APPLICATION NO.	FILING DATE	FIRST NAMED INVENTOR	ATTORNEY DOCKET NO.	CONFIRMATION NO.
10/699,389	10/31/2003	Chung Cheung	HKPC/370/US	3269
2543	7590	08/25/2005	EXAMINER	
ALIX YALE & RISTAS LLP 750 MAIN STREET SUITE 1400 HARTFORD, CT 06103			LANGDON, EVAN H	
			ART UNIT	PAPER NUMBER
			3654

<b>Office Action Summary</b>	<b>Application No.</b> 10/699,389	<b>Applicant(s)</b> CHEUNG, CHUNG	
	<b>Examiner</b> Evan H. Langdon	<b>Art Unit</b> 3654

## **DETAILED ACTION**

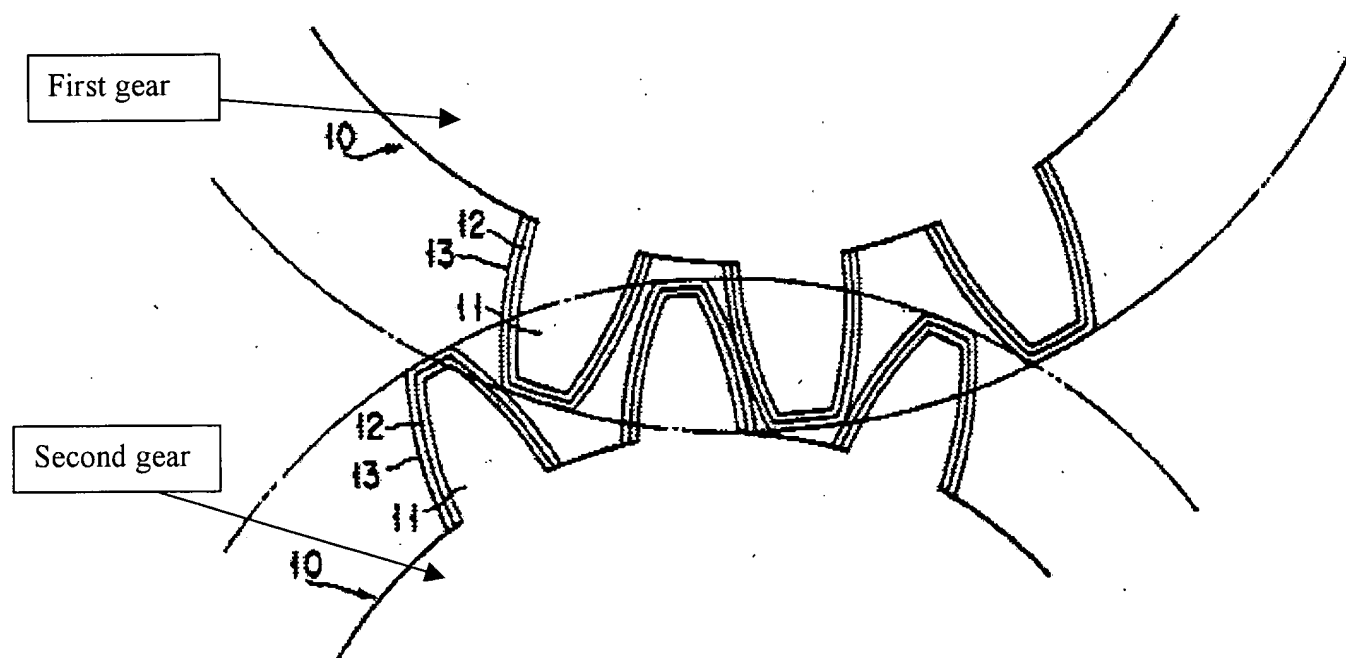
In regards to claim 1 and 12, Honda discloses a gear couple comprising:

a first gear 10 having a first meshing base, the first meshing base being covered by a first layer 13 which includes the element gold (col. 2, line36) disposed substantially uniformly over the meshing base;

a second gear 10 (see below) having a second meshing base, the second meshing base being covered by a second layer which includes the element chromium 12 (col. 2, line 65-67) disposed substantially uniformly over the meshing base,

wherein the first layer and the second layer engage in meshing contact.
